Access Compliance Report

Public Rights-of-Way

(Curb Ramps)

Intersection ID: 43482	Main Street: SAFARI_CT	Cross Street: ERWIN_RD	Location: SW
ADA ID: 0CD93D22A3D3	Ramp Type: PerpDiag	Initial Pass/Fail: Fail	Overall Compliance: No
Codes/Mitigation Info/Possible Solution		Field Measurements/Component Compliance	
Severity Score: 10

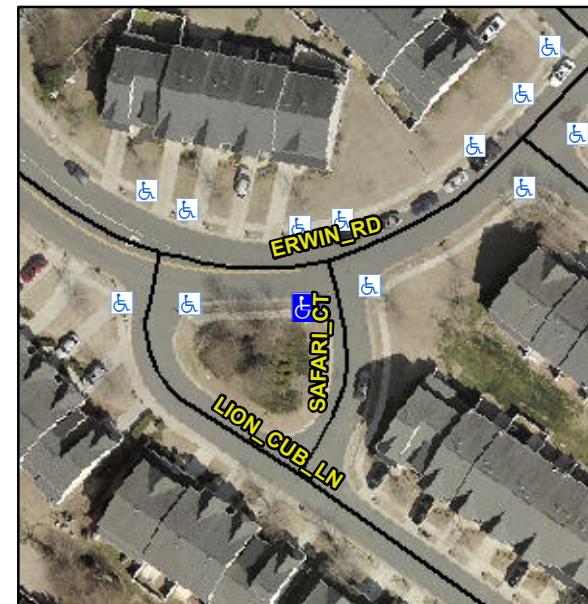
Not Found, R304.5.1, R304.5.3

Compliance	Description	Data	Compliance	Description	Data
N/A	Ramp Length (in)	48.0	Yes	Ramp Slope (%)	5.6
No	Ramp Width (in)	47.0	No	Ramp XSlope (%)	4.3
N/A	Flare Type LT	N/A	N/A	Flare Type RT	N/A
N/A	Flare Slope LT (%)	N/A	N/A	Flare Slope RT (%)	N/A
N/A	Flare Traversable LT?	N/A	N/A	Flare Traversable RT?	N/A
N/A	Landing Length (in)	N/A	N/A	DWS Provided?	N/A
N/A	Landing Width (in)	N/A	N/A	DWS Contrast?	N/A
N/A	Landing Slope (%)	N/A	N/A	DWS Length (in)	N/A
N/A	Landing X Slope (%)	N/A	N/A	DWS Full Width?	N/A
N/A	Landing Curb? (Y/N)	N/A	N/A	DWS Offset (in)	N/A
N/A	Shared Landing?	N/A			
N/A	Gutter Ponding?	N/A	N/A	Gutter Slope (%)	N/A
N/A	Gutter Lip Ht (in)	N/A	N/A	Gutter X Slope (%)	N/A
N/A	Painted X Walk1?	No	N/A	Painted X Walk2?	No
	X Walk 1 Direction	To E		X Walk 2 Direction	To N
N/A	X Walk 1 Width (in)	N/A	N/A	X Walk 2 Width (in)	N/A
	X Walk 1 Slope (%)	3.7		X Walk 2 Slope (%)	4.1
	X Walk 1 X Slope (%)	1.5		X Walk 2 X Slope (%)	3.9

Remove & Replace Curb Ramp With Two New Directional Ramps or Equivalent.
